03 June 2015
Job No: 68757

DDA Advice
Stockland Glendale, Lake Road, Glendale, NSW

FIGURE 2.3 EXAMPLE OF TWO PARKING SPACES WITH A COMMON SHARED AREA—DIMENSIONS FOR AUSTRALIA ONLY*

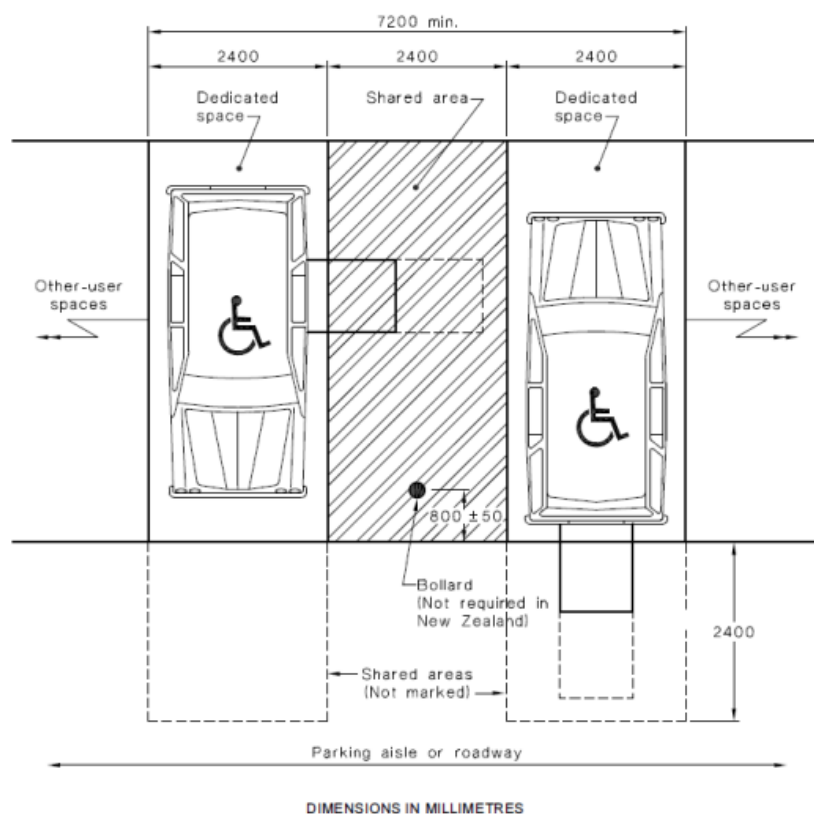
1. The adjacent shared area can be shared with any other suitable use, noting that it needs to be accessible in accordance with AS 1428.1 and free of other than transitory obstructions at all times
2. A similar area of length 2.4 m needs also to be provided at the end of the dedicated space for rear unloading/loading of a wheelchair. This can also be a shared area at the same level as the dedicated space. It is commonly shared with the parking aisle as illustrated in Figure 2.3 (below)

The comments provided by council contradict the minimum requirements of the standard and relate to safety matters and functionality, not compliance: *"This required area may cause conflict when located behind the space and on the circulation road, hence disabled parking spaces within the circulation road or on service vehicle routes are not supported unless the shared area is located in front of the disabled parking space or the parking spaces are parallel and compliant with AS2890.6"*.

The application of this non marked shared area at the end of an accessible bay is permitted to be shared with the vehicle way and is compliant with the specifications for angled parking as per AS2890.6:2009. Our review of the parking for this project confirms that compliance is achieved.
